Planning and Zoning Board Agenda

Agenda for May 5, 2025 at 6:30 PM

Subject: 1098 & 1106 E FULLERS CROSS ROAD (Preliminary Plat)

STAFF REPORT

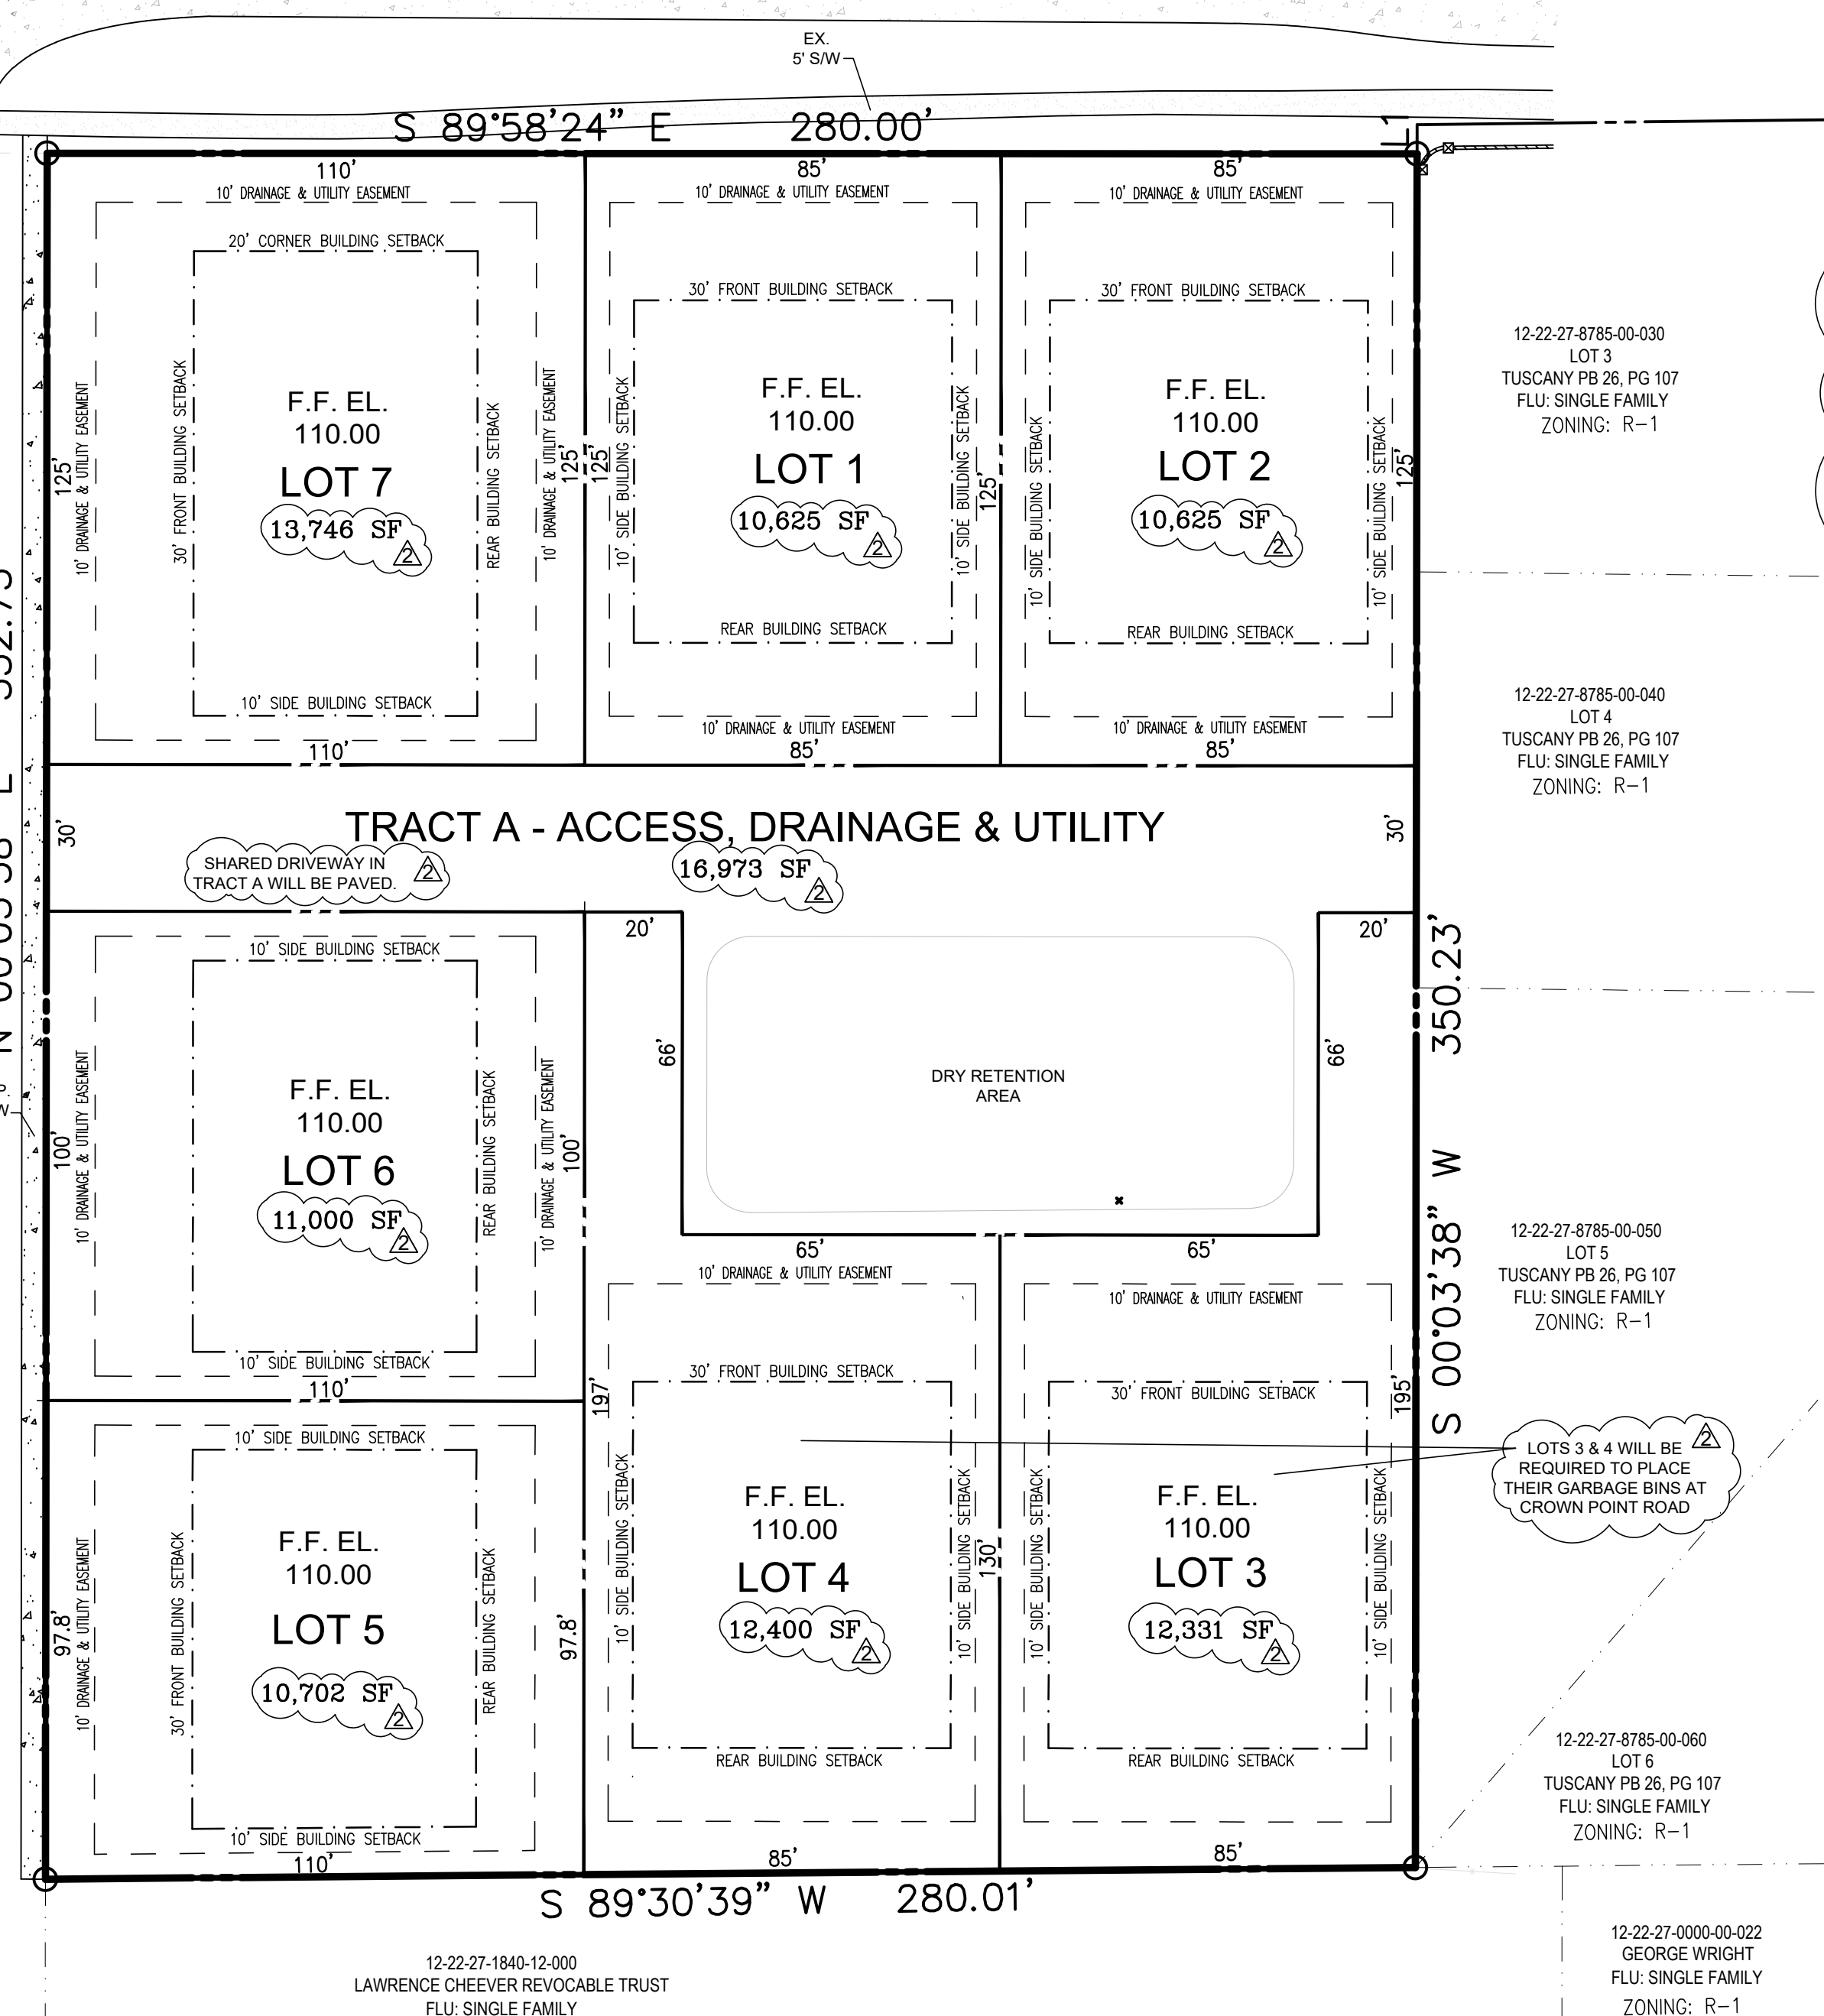
2. A minimum 10' wide drainage, utility and sidewalk easement is required adjacent to all rights-of-way. Side and rear drainage and utility easements required – as shown.

3. Minimum 5' wide concrete sidewalks are required along all project frontages as shown. Existing sidewalks will be checked at completion and any damaged sections shall be replaced.

- b. Tract A, access & utility easement shall be paved as shown.
 - c. The owners of Lots 3 & 4 shall be required to place their garbage bins on West Crown Point Road since access is not being provided for solid waste trucks to these lots.

- DURING CONSTRUCTION PLAN REVIEW THAT APPLICANT WILL BE REQUIRED TO SUBMIT A LANDSCAPE PLAN AND FENCE DETAIL FOR TRACT B. THE FENCE SHOULD BE PROVIDED ALONG THE REAR PROPERTY LINES OF LOT 8, 9 AND 10.
